PLANNING COMMISSION STAFF REPORT

AGENDA ITEM: Century Ponds Proposed Development, 601 Century Avenue South

Public Works Plan Review

PLAN SET: Plans dated 7-22-2025

Prairie D

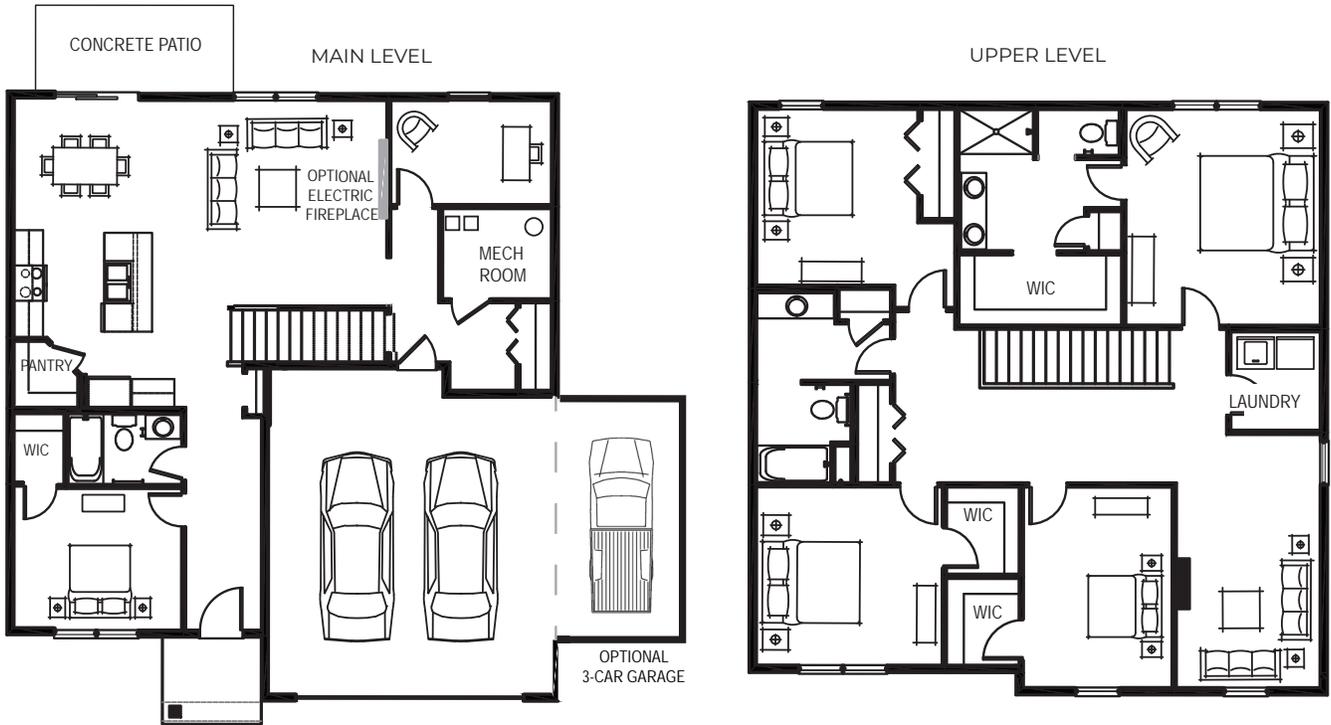
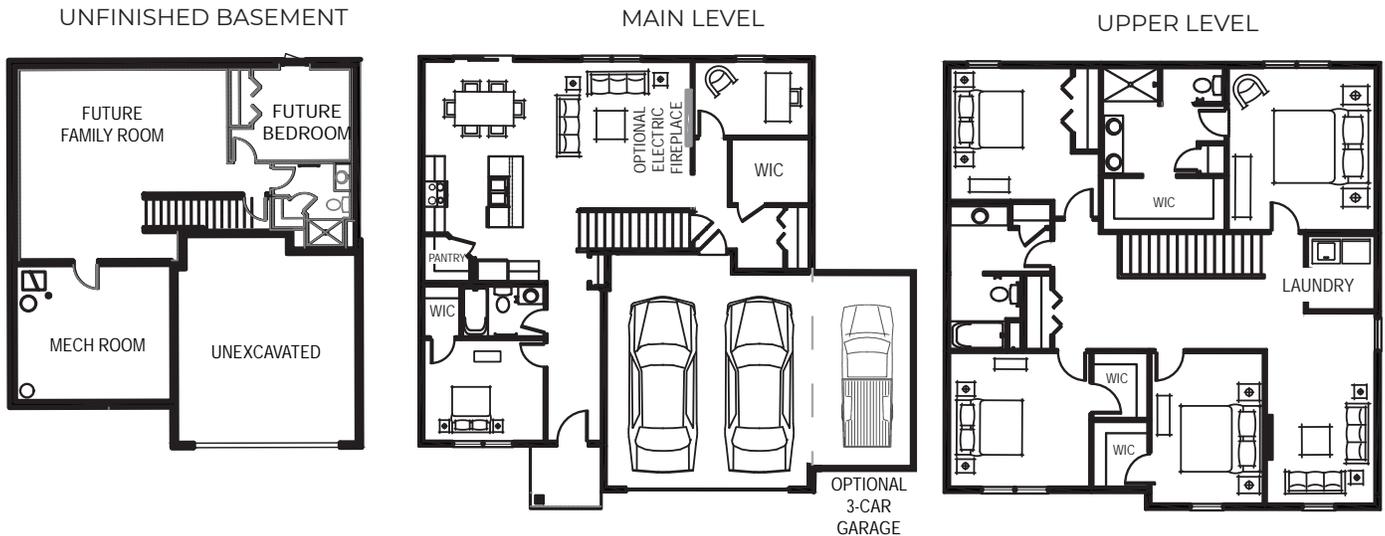
The exterior design and appearance of all single-family homes in this PUD must be approved by the director of community development. The review is required to ensure the exteriors of the homes are not similar in design. No single-unit home will be constructed with the same floor plan or exterior facade as a home immediately adjacent to it or across the street. In addition, all single-unit homes and townhomes shall be constructed of building materials that mitigate the noise from the adjacent shooting range.

The Elliot/Finley

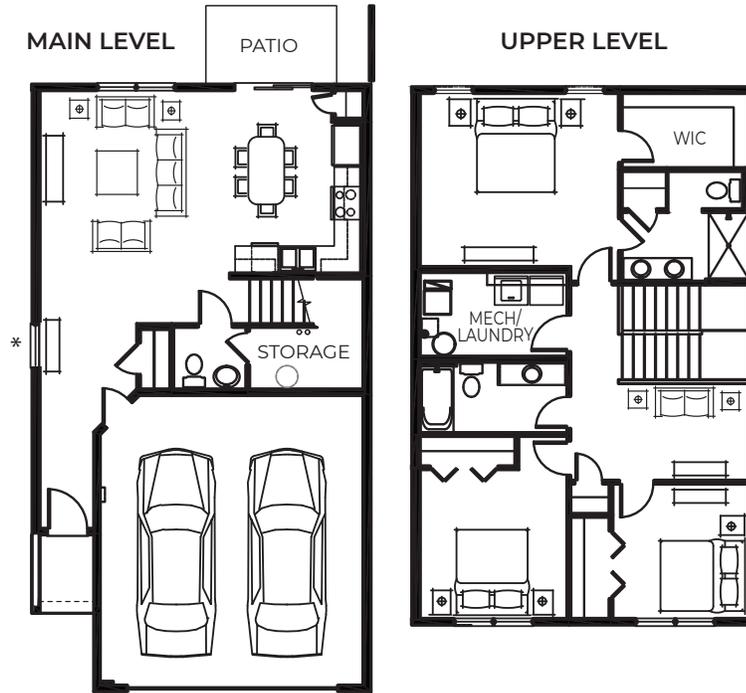
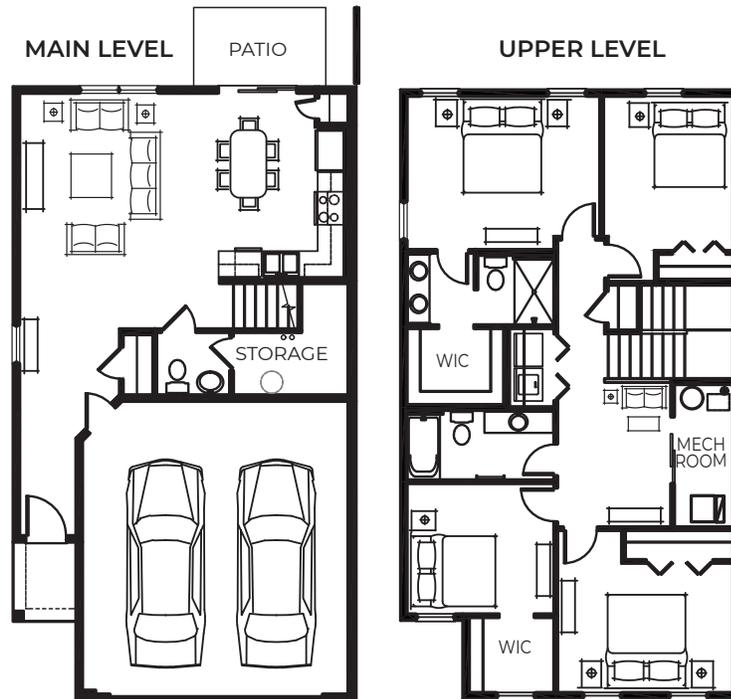
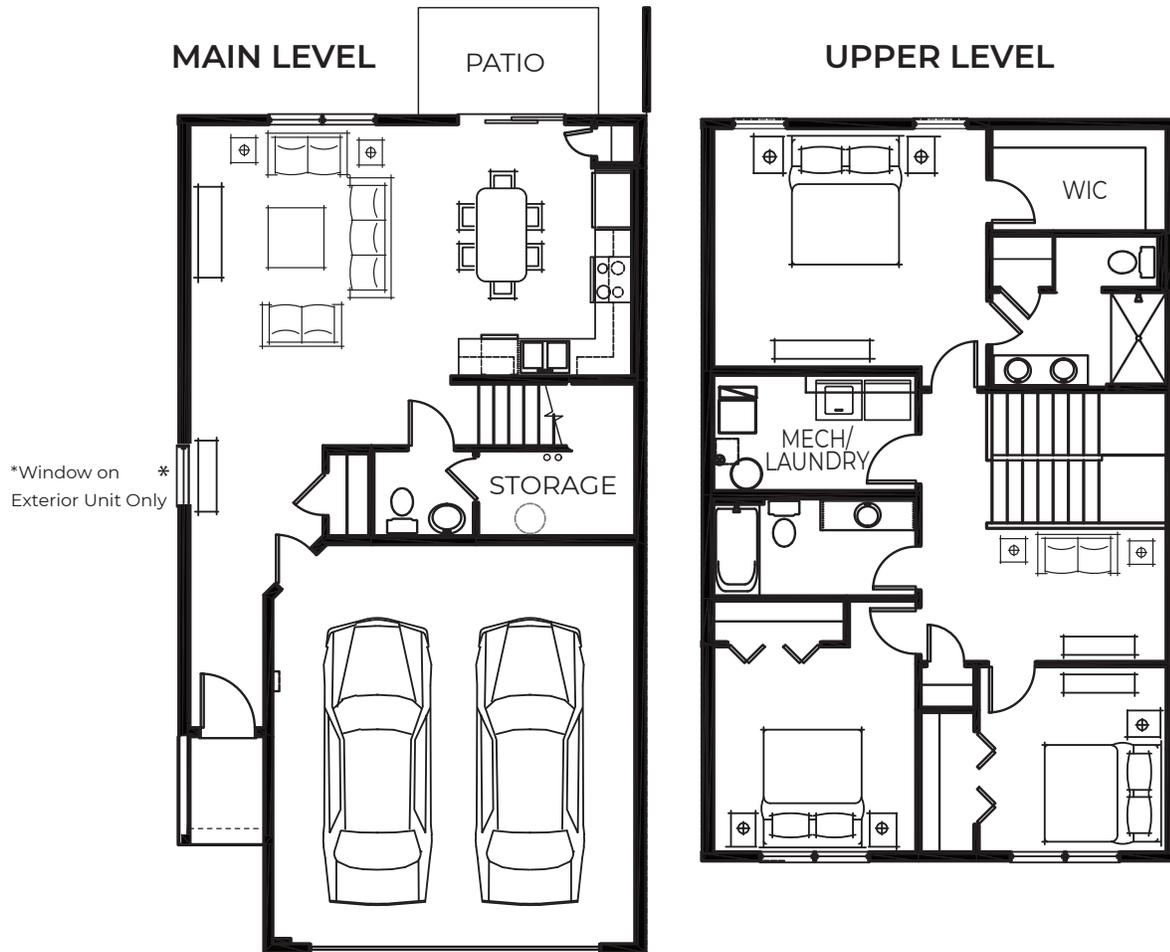
Staff believes the side and rear elevations of each building should have more architectural elements added to improve the aesthetics of the buildings. Additionally, there are opportunities to add additional windows on the second floor of the side elevations and to wrap the stone wainscotting around to the rear elevation.

Low Floor Analysis

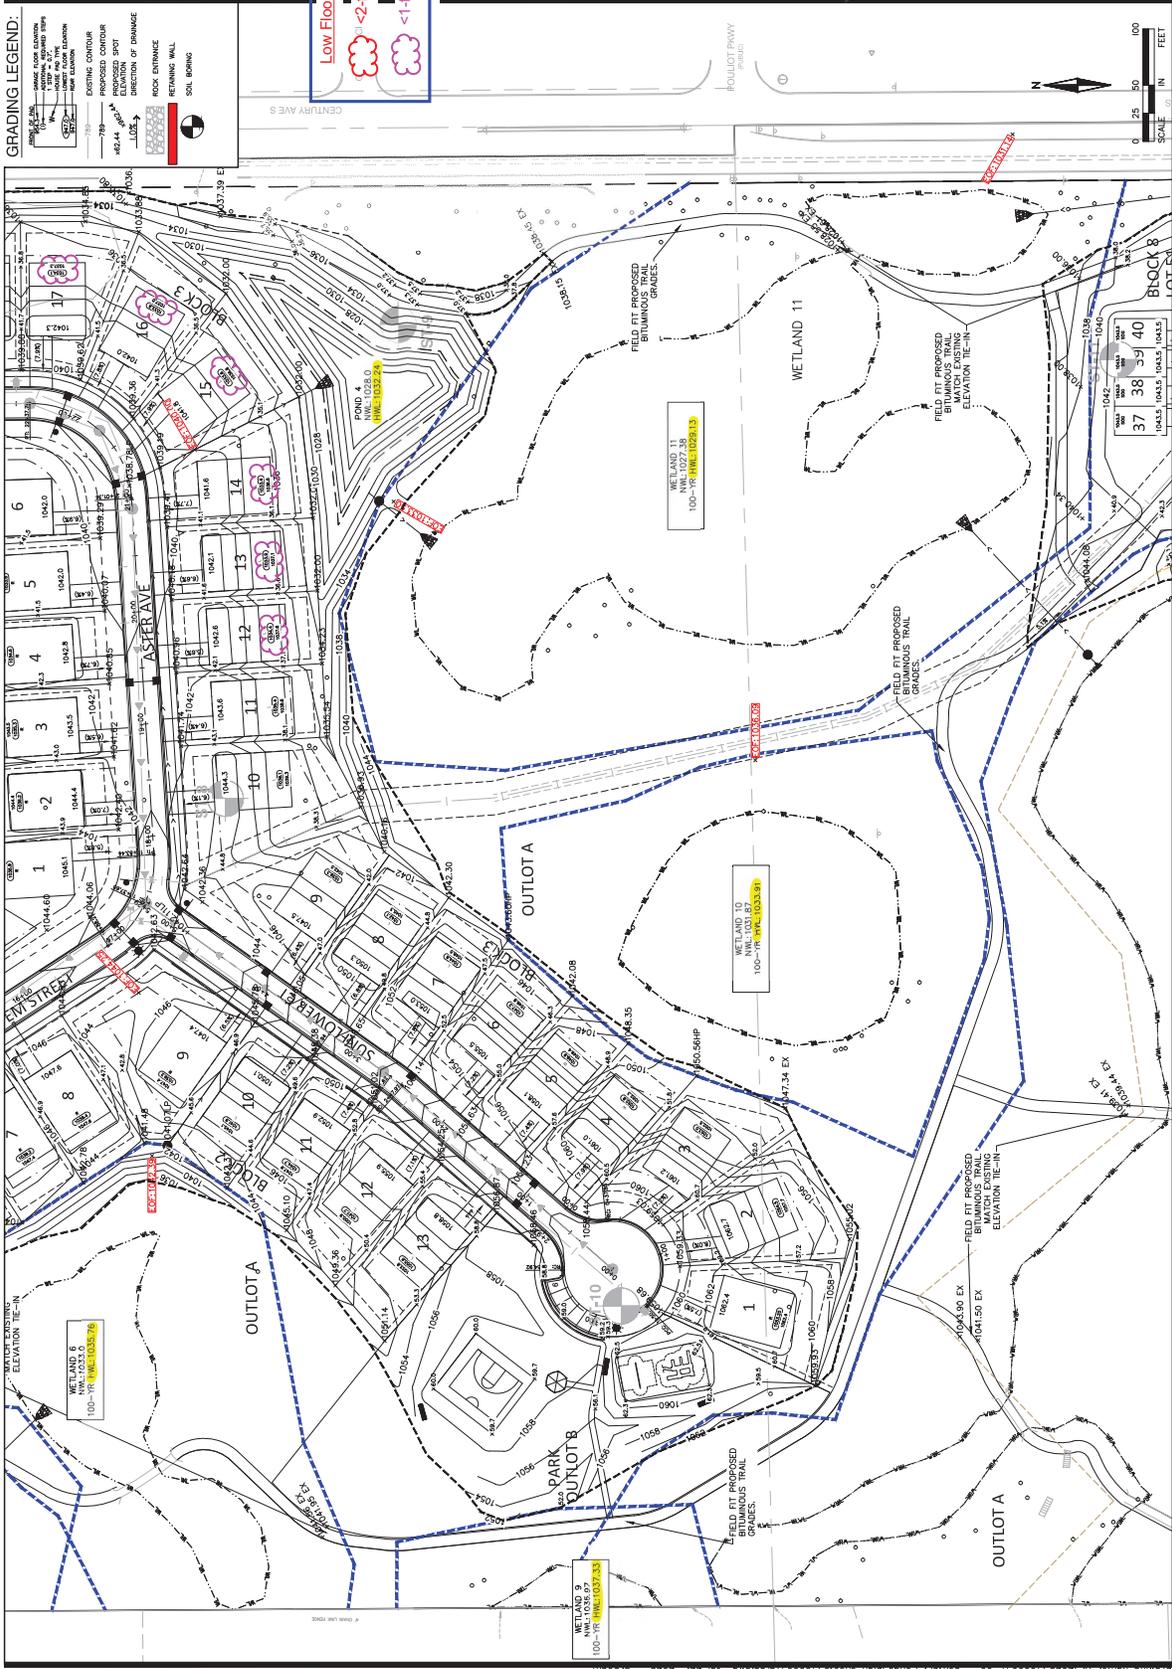
- <2-ft above HWL
- <1-ft above EOF
